AGENDA
PARKS, RECREATION & NATURAL RESOURCES COMMITTEE
MEETING

To: Planning Commission
From: Kris Jenson, Planning Manager
Date: September 24, 2024
Subject: Packet Material for the October 3, 2024 Planning Commission Meeting

Crown LMN, LLC has submitted applications and plans for a preliminary plat and conditional use permits for Crown Lakeville Apartments, which proposes one lot and one outlot two multi-family apartment buildings on about 10 acres of land located north of 210th Street (CSAH 70) and west of Keokuk Avenue. The property currently includes a single-family home and is heavily wooded.

SHEET
L-1.01
REV.

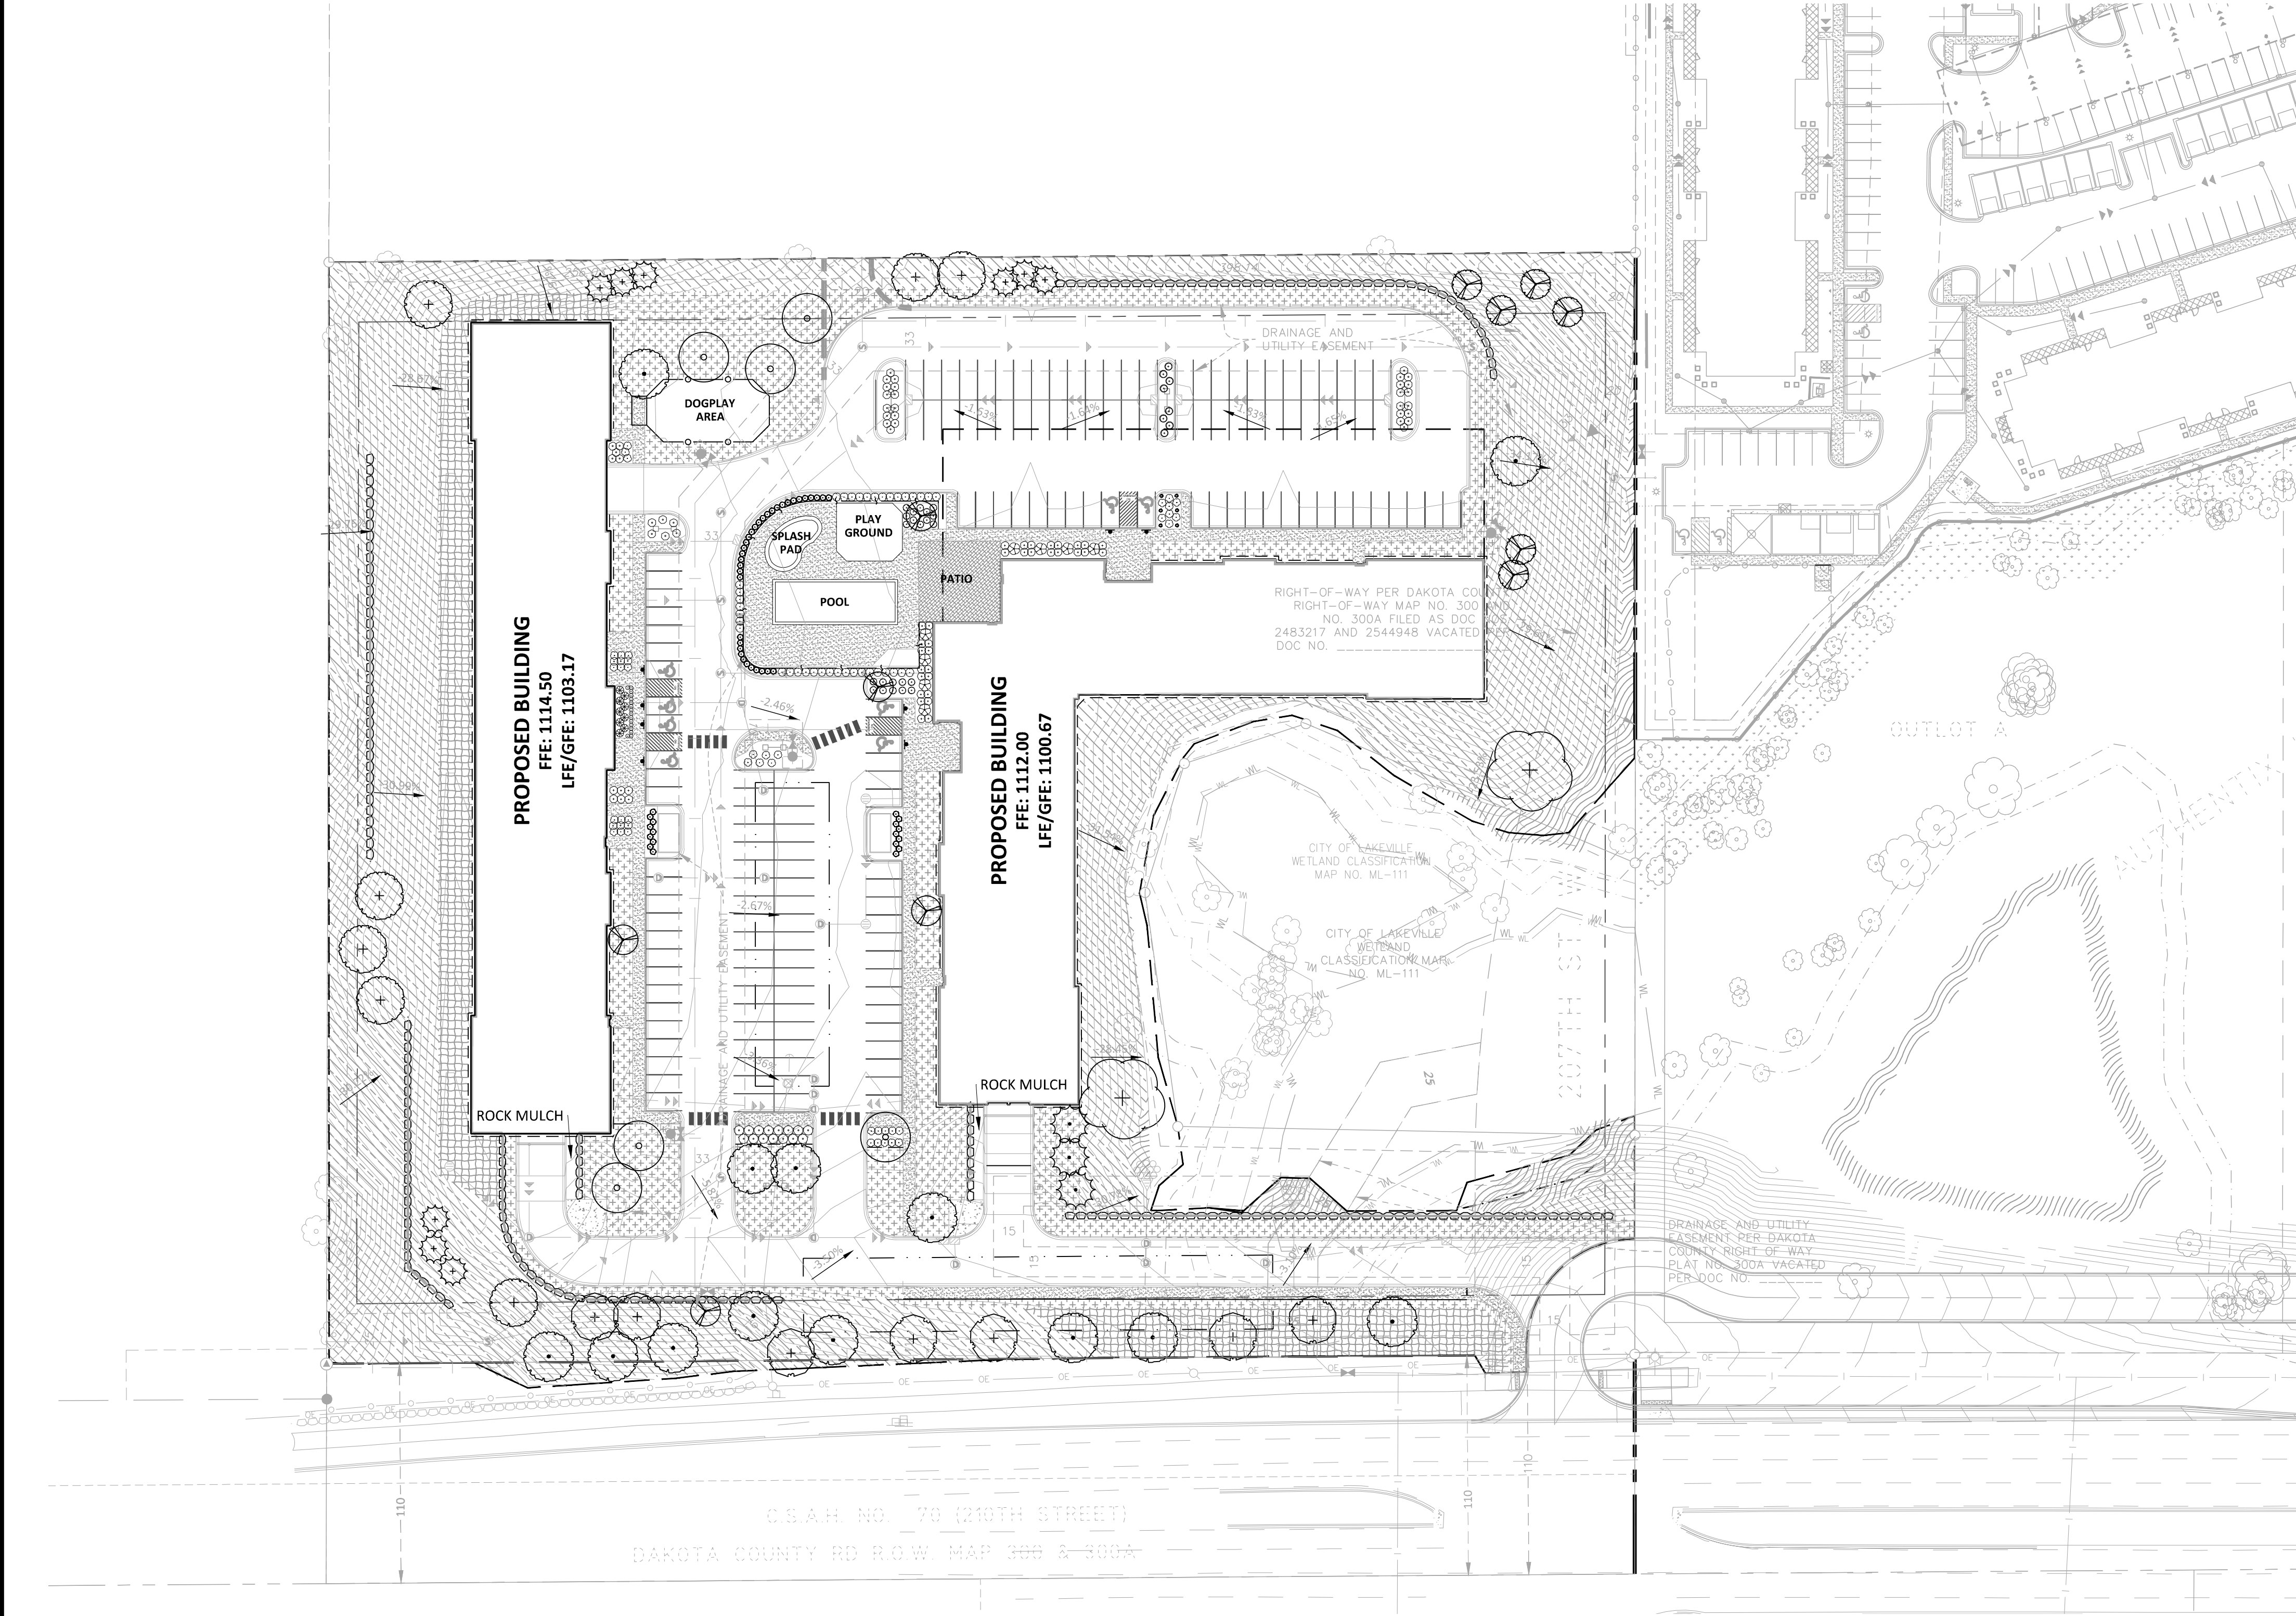
G. General site screening and landscaping shall be provided in compliance with chapter 21 of this title. The landscape plan (Exhibit J) includes a row of overstory trees between 215th Street and the access drive to the site, within the parking lot islands, and scattered around the remainder of the site. Prior to City Council consideration of the preliminary plat, the plant schedule must be updated to reflect that all conifers must be a minimum of eight feet in height at the time of planting and identify minimum shrub heights in accordance with Zoning Ordinance requirements, not container size as shown.

7. Prior to City Council consideration, the plant schedule on the landscape plan must be amended to show a minimum planting size of eight feet for all conifers and to identify minimum shrub heights in accordance with Zoning Ordinance requirements, not container size as shown.
8. Prior to City Council consideration, the site plan must be modified to meet the Floor Area Ratio (FAR) of 0.7.

SD501

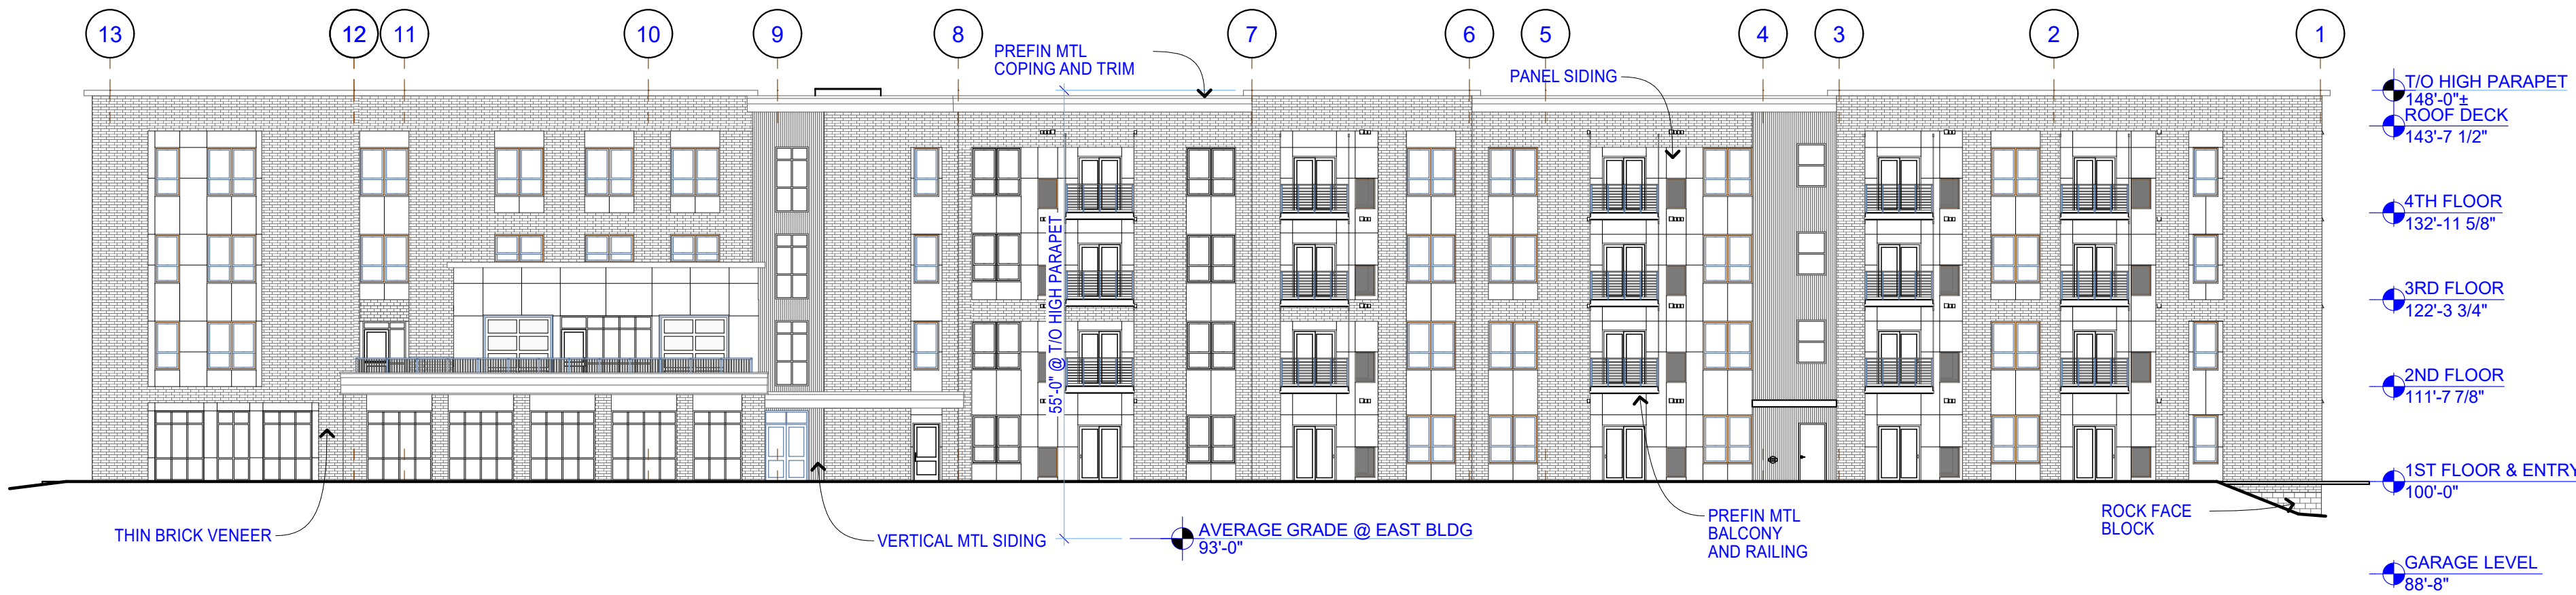
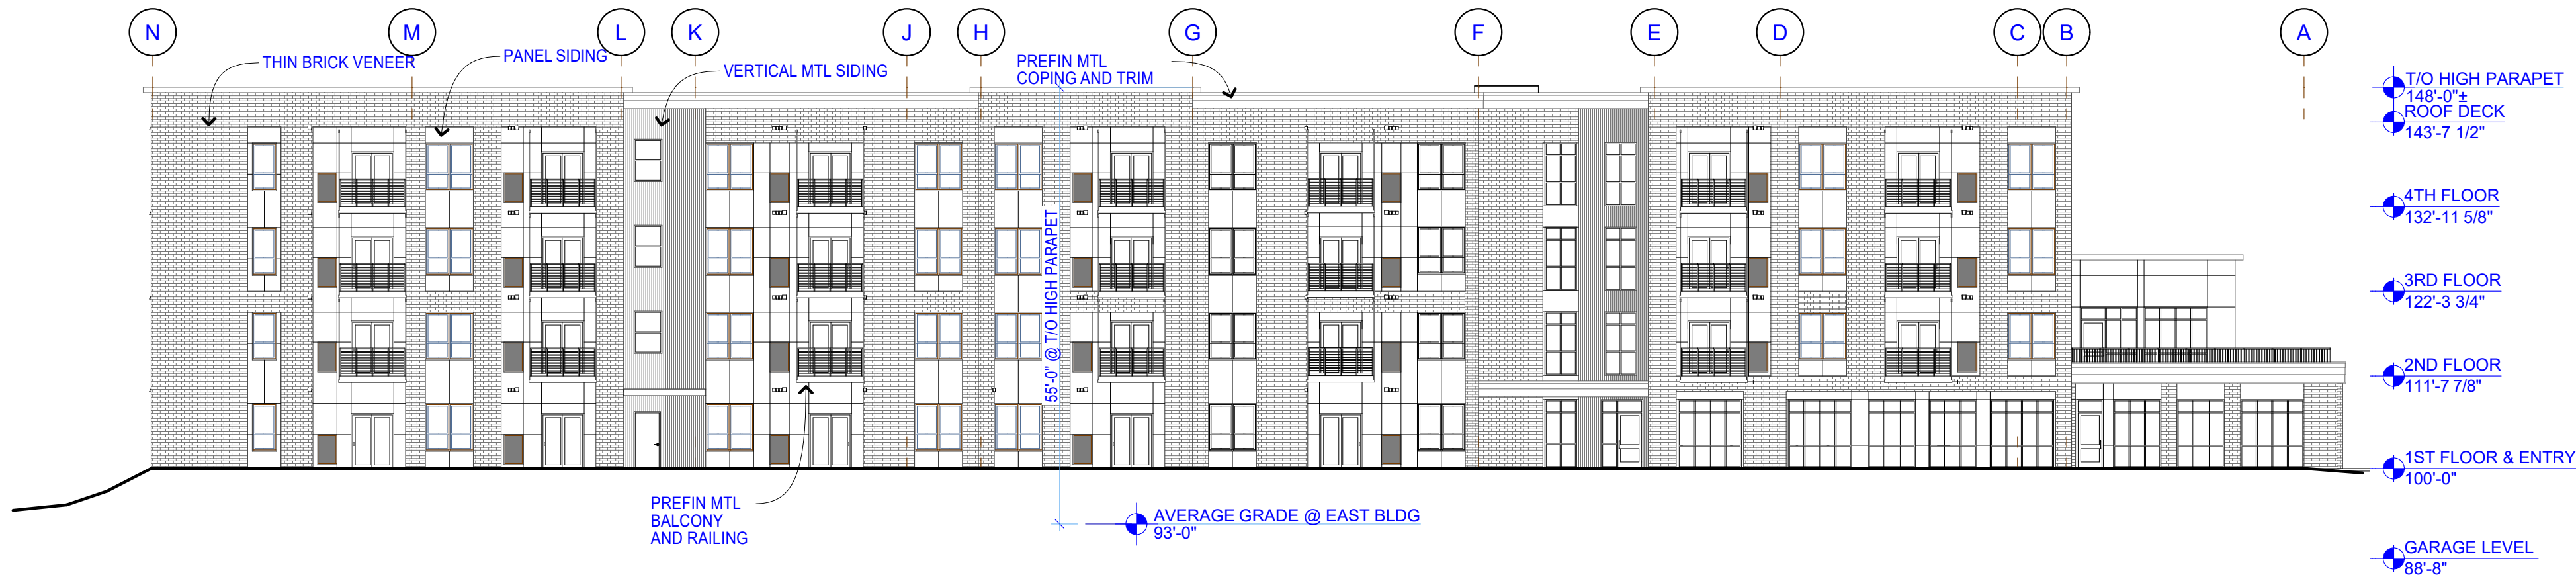
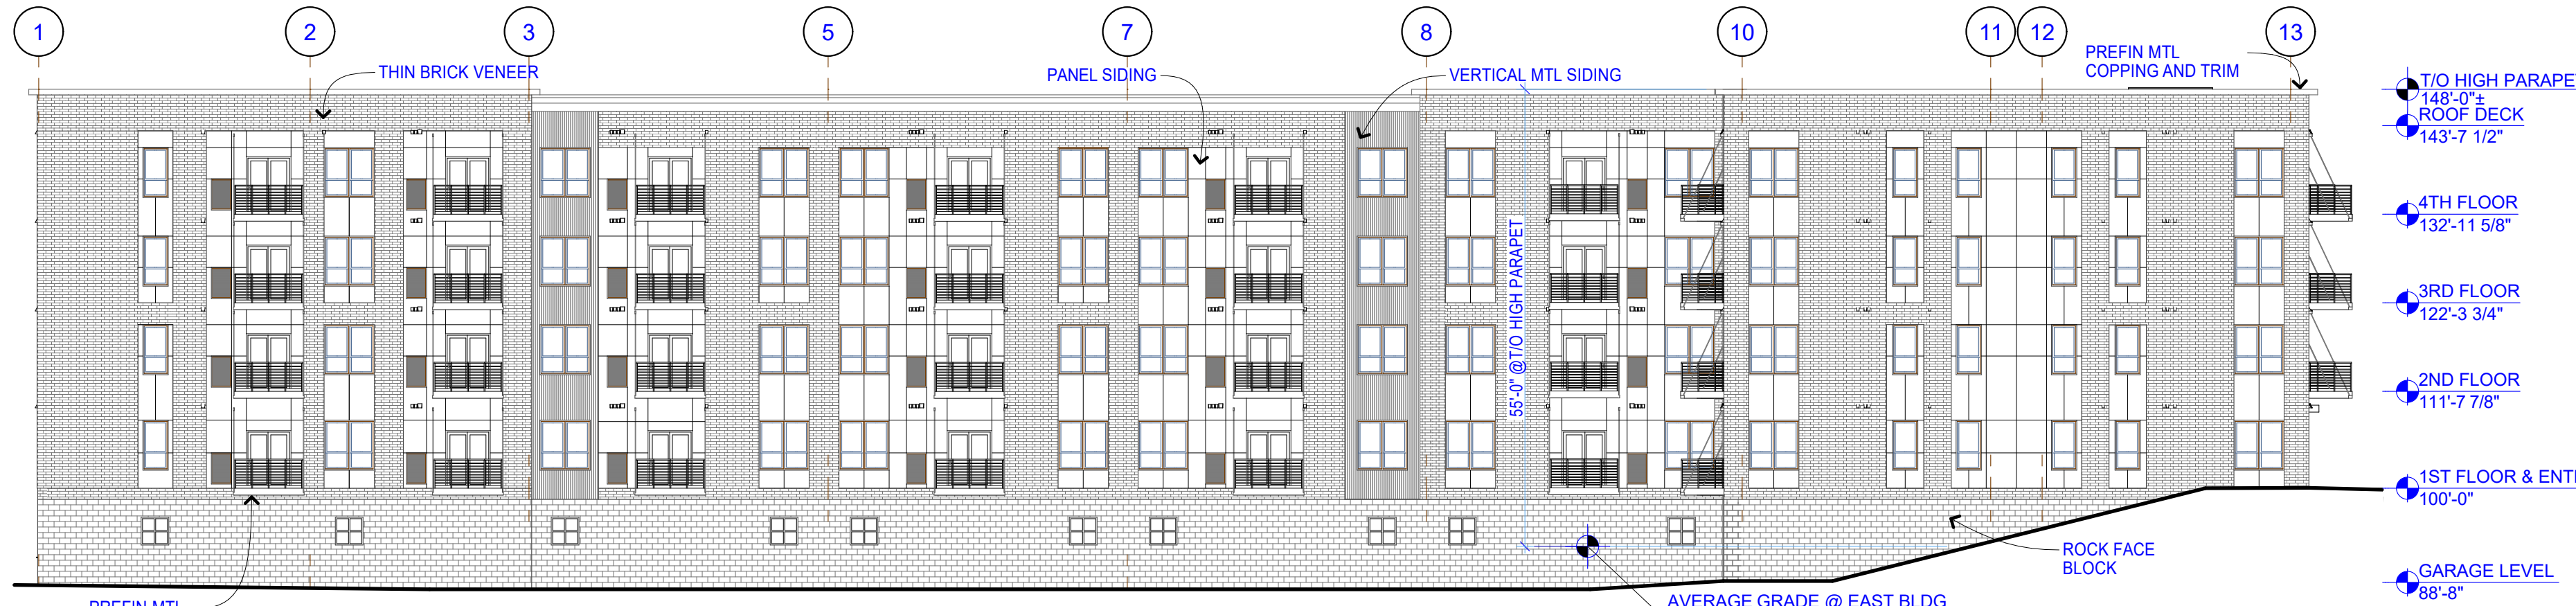
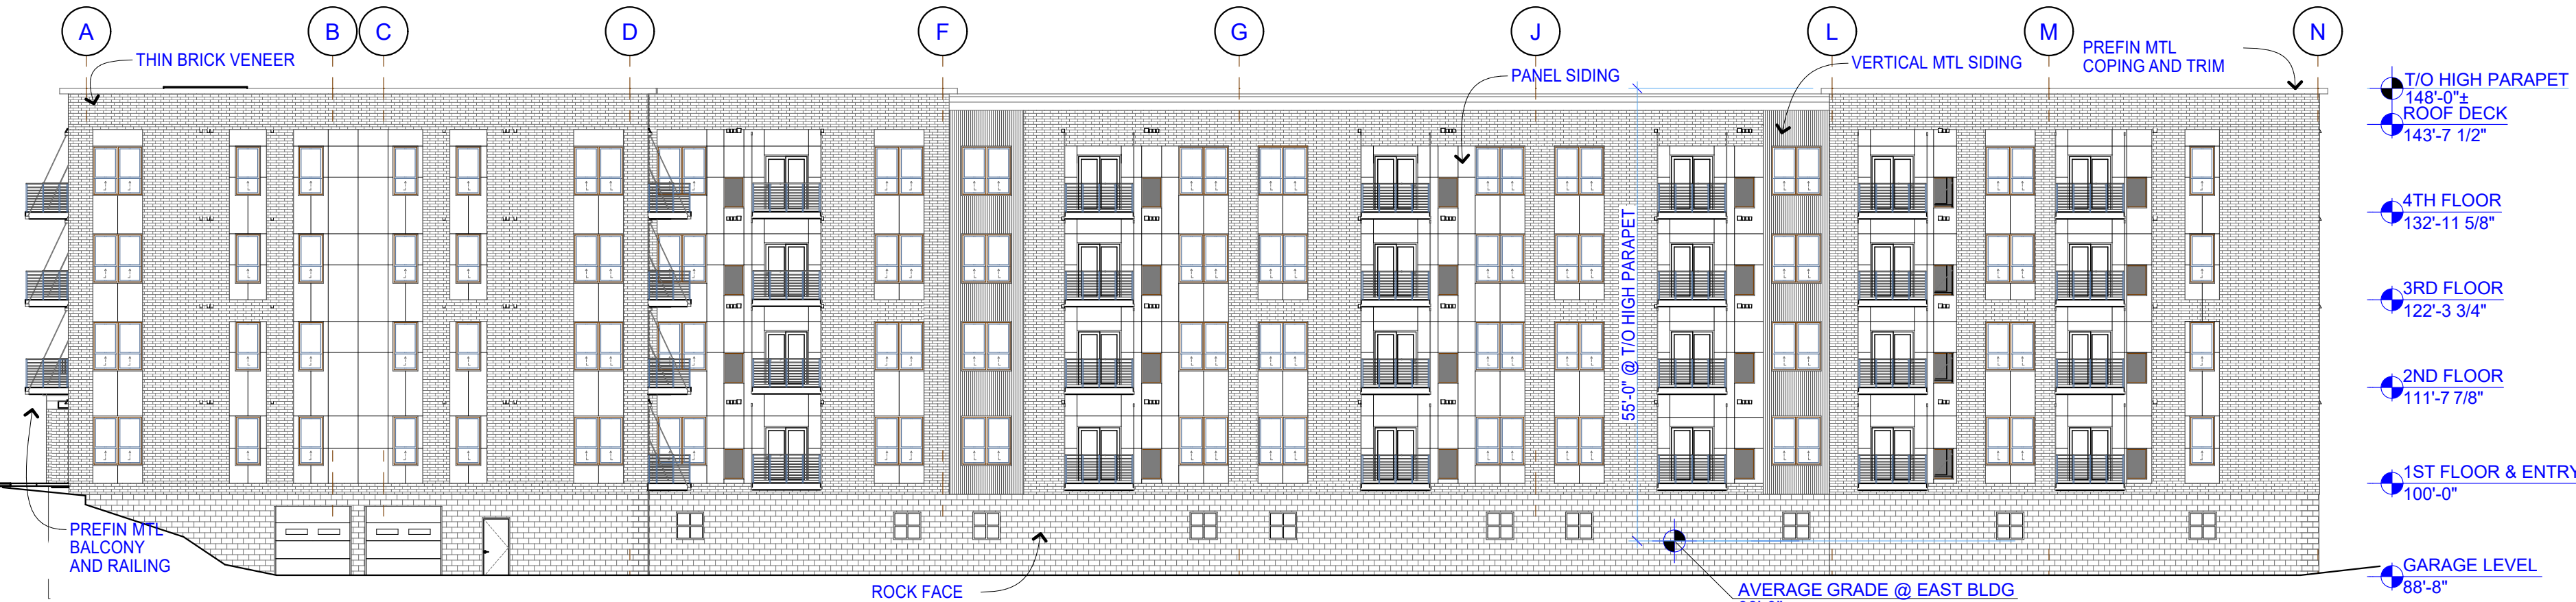
Exhibit K shows that the east building’s average grade is 93 feet (for the purposes of measuring building height, the first-floor grade is marked at 100 feet, and all other measurements based off that elevation) and that the parapet height is 148 feet. Based on the Zoning Ordinance definition, the building height is 55 feet. The plan shows that the roof deck is 43 feet, 7 inches, which is 4 feet, 5 inches below the parapet. Parapet walls less than three feet above the limiting height of the building are exempt from building height limits, which does not apply to this building.
